MEMORANDUM

REVIEW TYPE: Preliminary Plan of Subdivision

PROJECT NAME: Liberty Heights

CASE NO. 120060620

GERMANTOWN, MARYLAND (ELECTION DISTRICT 02)
LIBERTY HEIGHTS
 (NGUYEN PROPERTY)
PRELIMINARY PLAN

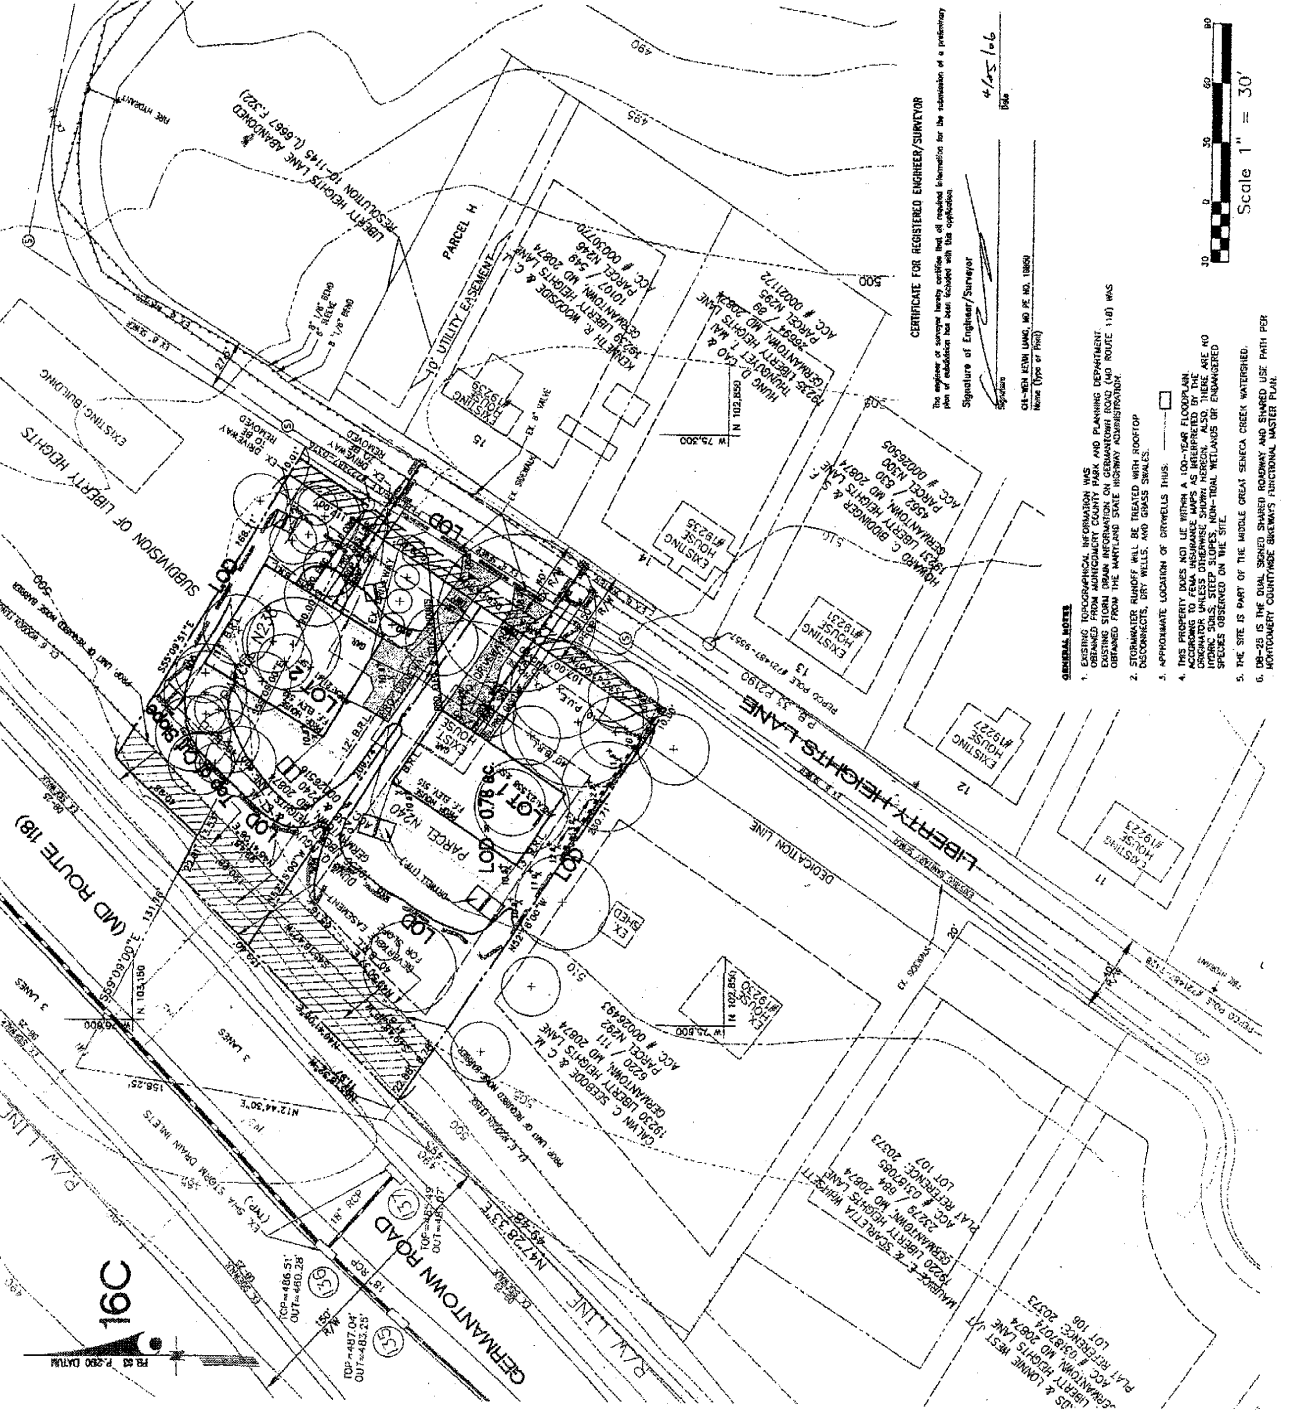
The Environmental Planning staff has reviewed the preliminary plan referenced above. Staff recommends approval of the preliminary plan of subdivision with the following conditions:

- 1) The proposed development shall comply with conditions for approval of a final tree save plan, per the conditions for exemption from forest conservation dated September 13, 2005. The final plan must be signed and approved by MNCPPC staff prior to any demolition, clearing, or grading on the subject property. Final plan must be in accordance with all conditions as follows:

- a. The final tree save plan must save trees shown for save on the tree save plan dated 4/26/2006. Any trees that need to be removed based on the further arborist's review must be replaced at a rate up to 1" DBH per every 1" lost.

- b. Final tree save plan must be prepared, signed and stamped by an ISA certified arborist and include complete details on the proposed tree protection measures.

- c. Required site inspections by M-NCPPC enforcement staff per Section 110 of the Forest Conservation Regulations.
- 2) Applicant shall construct a noise wall or an acoustically-effective fence in the approximate location of the current fence along Route 118 prior to occupancy. The top of barrier shall be at a minimum elevation of 506' MSL along its entire length.

We have completed our review of the preliminary plan dated 11/18/05. This plan was reviewed by the Development Review Committee at its meeting on 01/09/06. We recommend approval of the plan subject to the following comments:

1. Show all existing planimetric and topographic details specifically paving, storm drainage, driveways adjacent and opposite the site, sidewalks and/or bikeways as well as existing rights of way on both sides of the streets and easements on the preliminary plan.

2. Right of way dedication for Germantown Road in accordance with the master plan and as necessary for Liberty Heights Lane.
3. Grant necessary slope and drainage easements. Slope easements are to be determined by study or set at the building restriction line.

4. We did not receive complete analyses of the capacity of the downstream public storm system(s) and the impact of the post-development runoff on the system(s). As a result, we are unable to offer comments on the need for possible improvements to the system(s) by this applicant. Prior to approval of the record plat by the Department of Permitting Services (DPS), the applicant's consultant will need to submit this study, with computations, for review and approval by DPS. Analyze the capacity of the existing downstream public storm drain system and the impact of the post-development ten (10) year storm runoff on same. If the proposed subdivision drains to an existing closed section street, include spread and inlet efficiency computations in the impact analysis.

5. The sight distances study has **not** been accepted. Prior to approval of the record plat by DPS, the applicant's engineer will need to submit a revised sight distances certification. The revised form will need to reflect the correct classification (secondary residential roadway) and speed limit for the existing and proposed driveway(s) to achieve a minimum of two hundred (200) feet of sight distance in each direction.

6. Record plat to reflect denial of access along Germantown Road (MD 118).
7. Access and improvements along Germantown Road (MD 118) as required by the Maryland State Highway Administration.
